**Town of Clarkstown
New City , New York
Highway Garage Expansion Project
Bid Number 21-2024**

**Addendum No. 3
August 28, 2024**

Subject: Town of Clarkstown
Highway Garage Expansion Project
Bid No. 21-2024

VENTILATION FANS

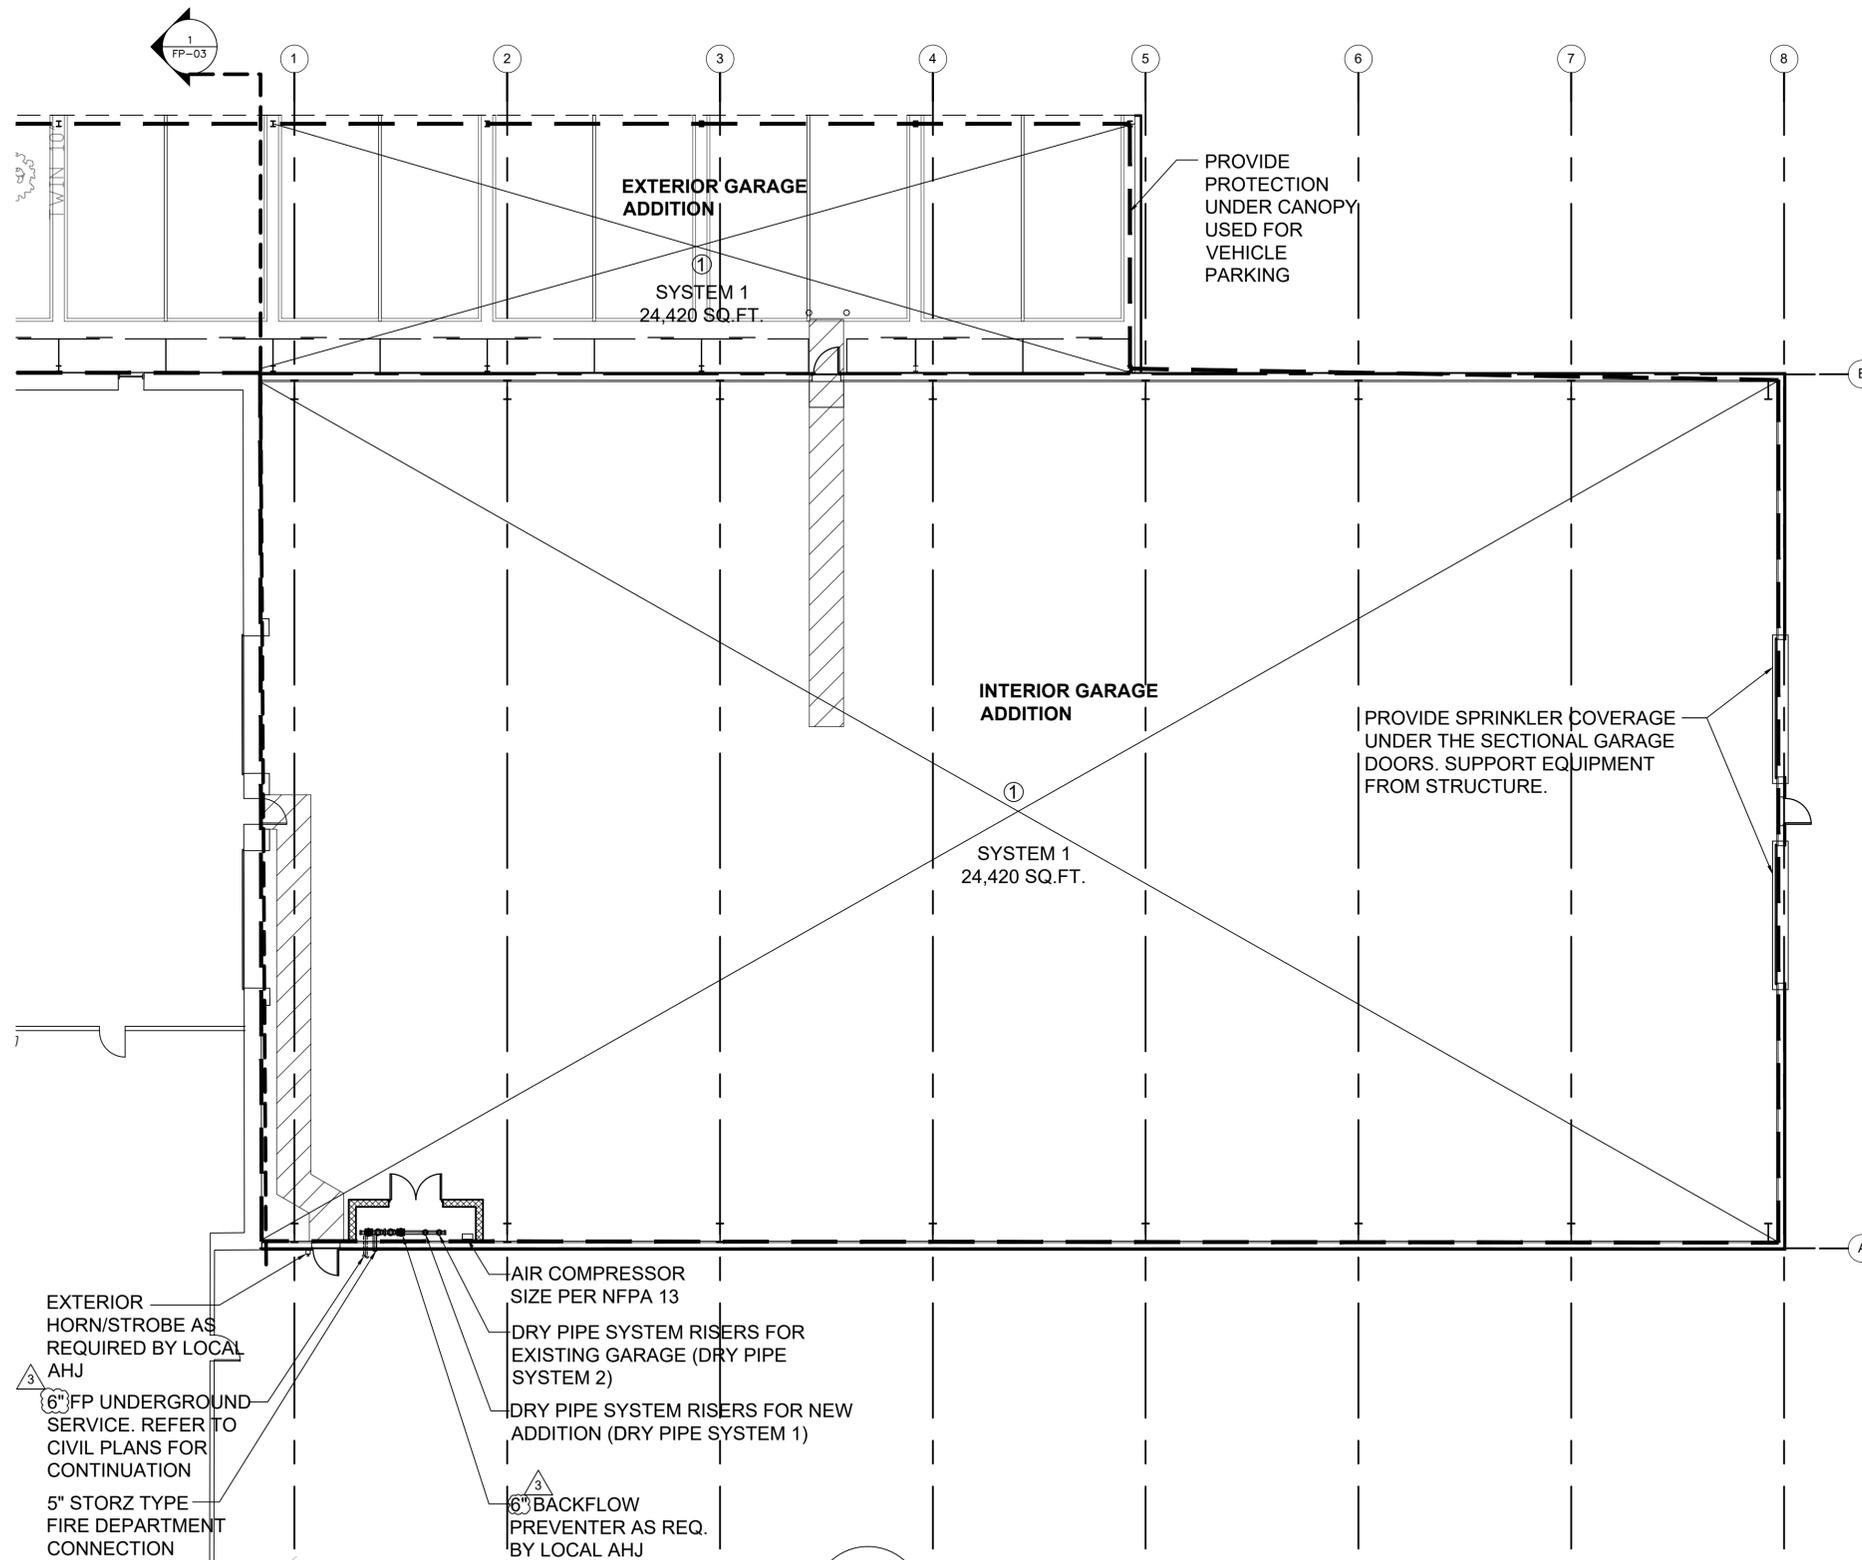
1. Sheet C-02, Proposed Site Plan, Delete note “New Above Grade Enclosure”
2. Sheet C-07, Site Details 3, Delete detail 18/C-07 and associated notes.
3. Sheet P-02, Revised as attached
4. Sheet H-04, Detail 4/H-04, Revise to be installed in metal framed opening in the PEMB wall.
5. Sheet H-05, Revised schedule as attached.
6. Sheet FP-02, Fire Protection Plan, Revised as attached.
7. Sheet E-02, Electrical Site Plan, Delete circuits C-33 and C-35 and associated notes at Hotbox since deleted from scope.
8. Sheet E-05, Single Line Diagram and Panel Schedule, Delete breakers at circuit 33 and 35 will be left as spares.

1. Drawing H-05 Lists "Greenheck" Ventilation Fans EF-01, EF-02, EF-03, EF-04 as Models AER-30-VG, according to the manufacturer rep these fans model number are not available with the performance given. Please review and provide correct model number with performances given.

Response – Refer to the revised mechanical schedule in changes to Drawings above. Fan performance has been corrected and the contractor should be able to obtain the specified fan.
